TITLE: ZBA 09-01: 418 W. Wilson Avenue

**VILLAGE OF LOMBARD
INTER-DEPARTMENTAL REVIEW GROUP REPORT**

ZBA 09-01; 418 W. Wilson Avenue: The petitioner requests that the Village approve the following actions for the subject property located within the R2 Single-Family Residence District:

Attachment B

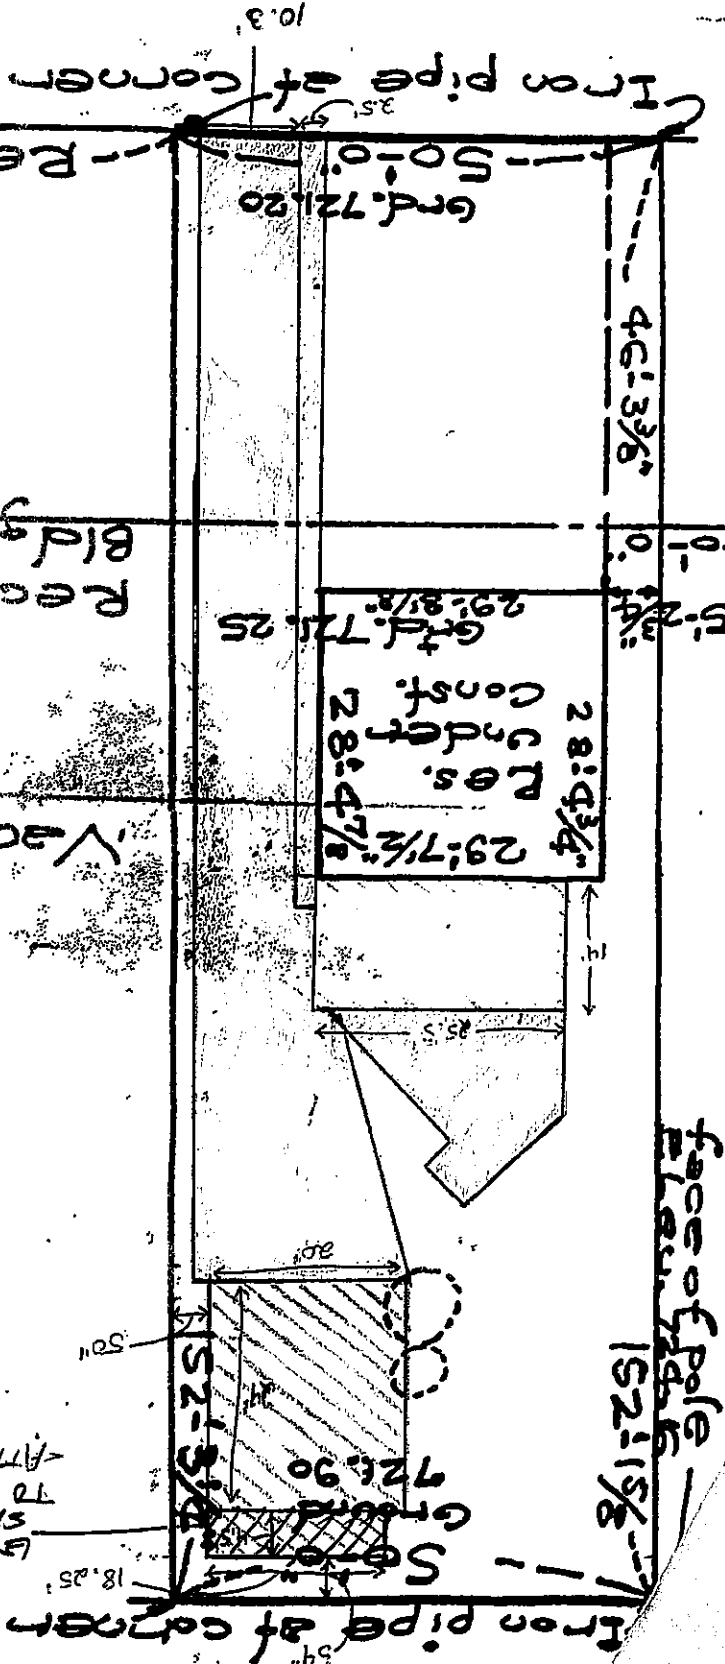
Chairperson Defalco examined Attachment C in the staff report and compared it to the petitioner's Exhibit C. He stated that the areas constructed without a permit were marked A, B, C, and D in Attachment C. He stated that the extensions of the driveway were not shown on the permit (Exhibit C).

Mr. Bedard stated that the permit shows this area as open space

Attachment C

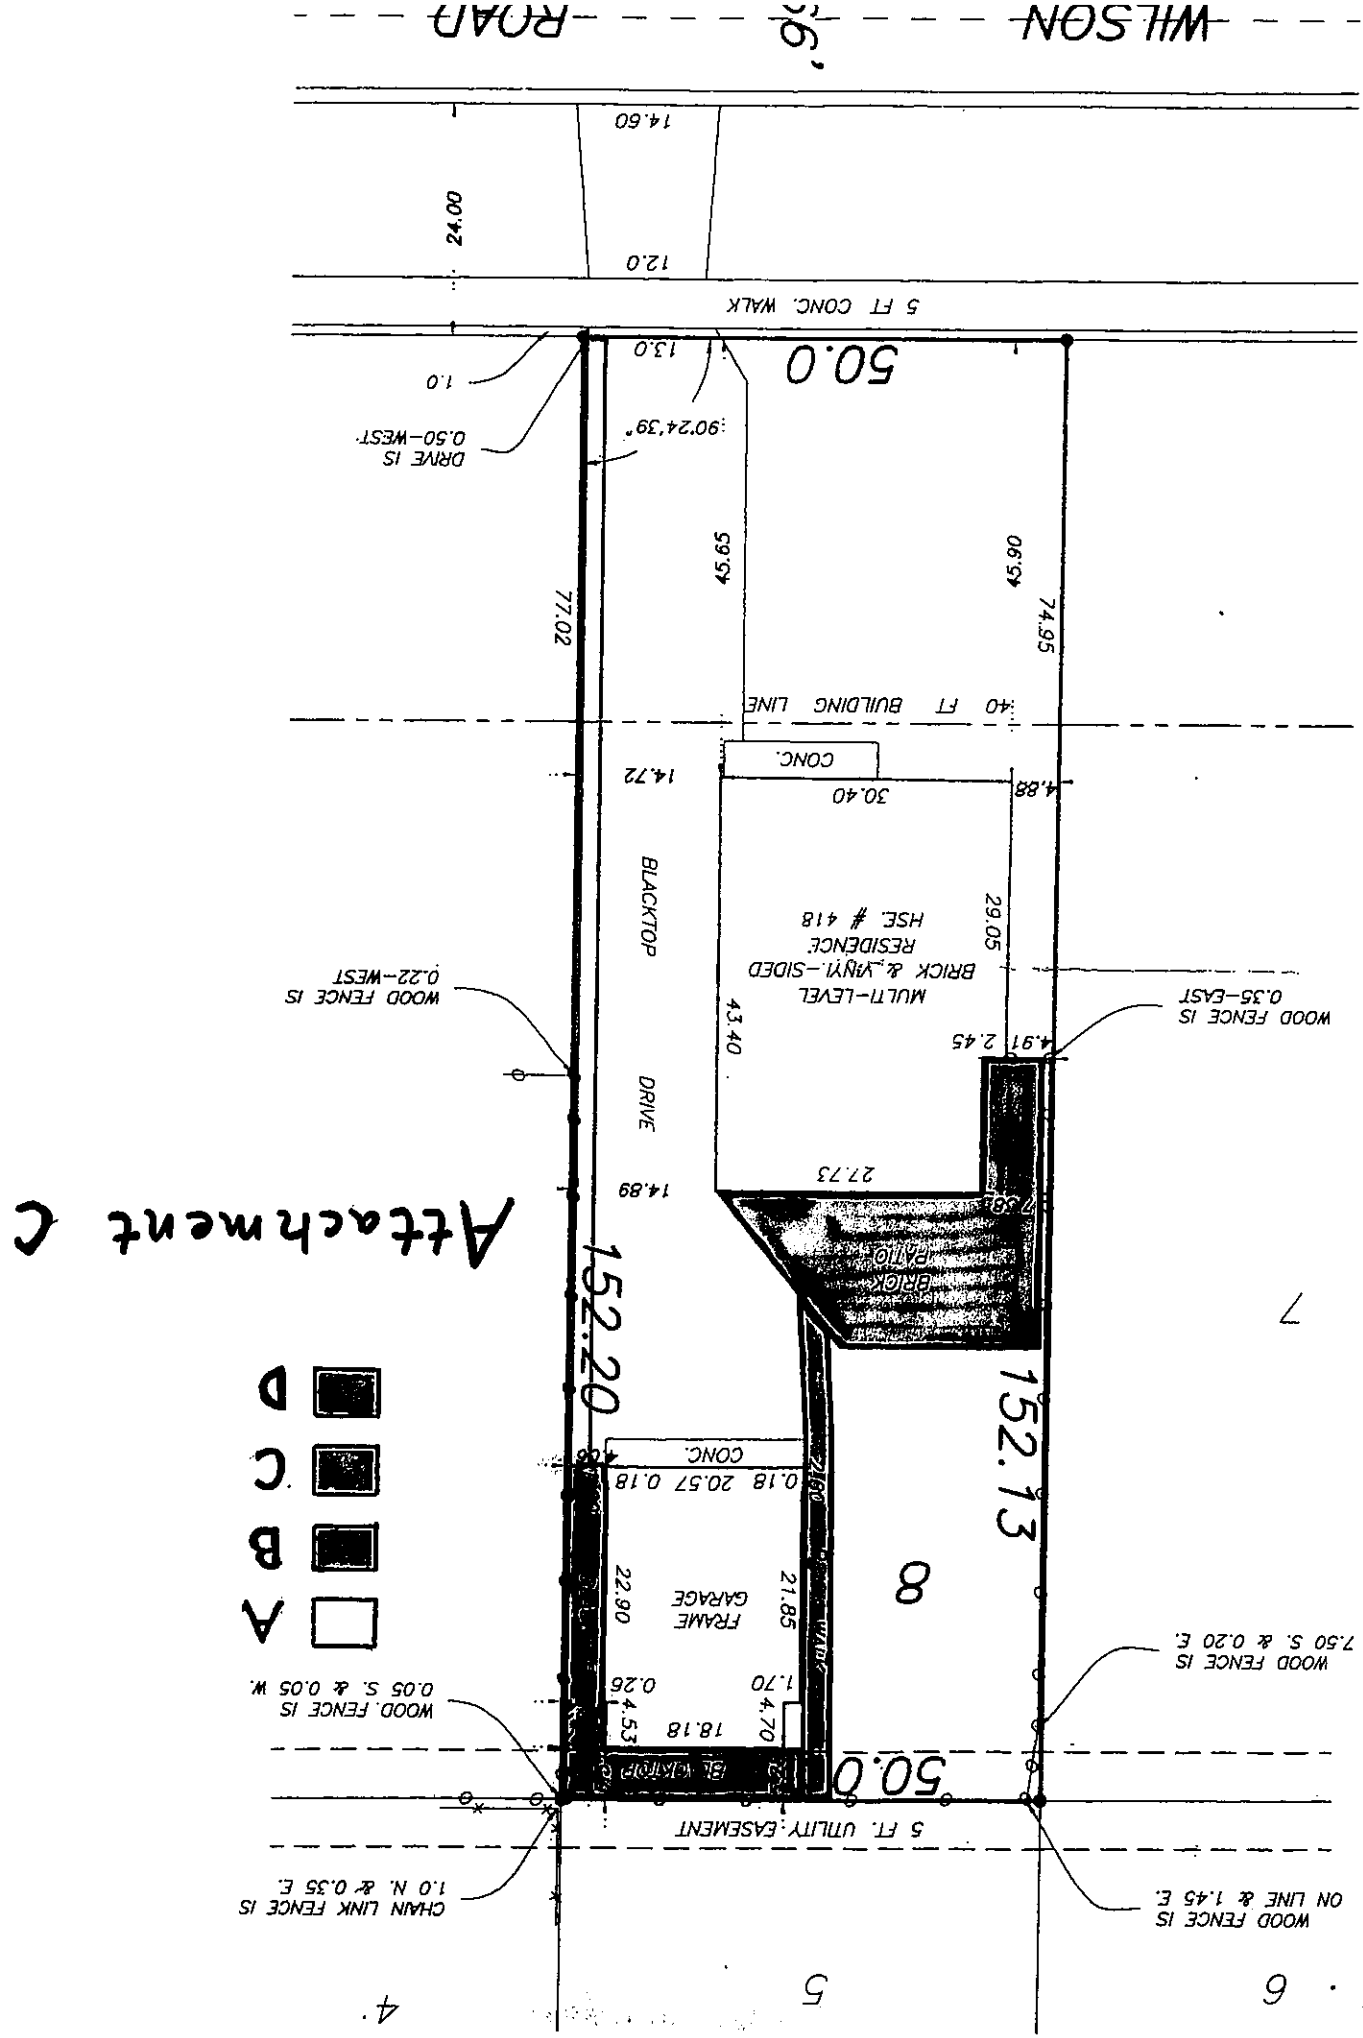
Upon an inspection of the lot by Building Division staff, it was discovered that additional impervious surfaces had been constructed which were not depicted on any of the permit applications. (See Attachment C.) These surfaces consist of:

- A. A two and one half foot strip of asphalt located along the eastern property line
- B. Asphalt paving behind and to the east of the garage
- C. A brick paver deck occupying the area to the rear and west of the residence
- D. A brick walkway from the garage to the deck.
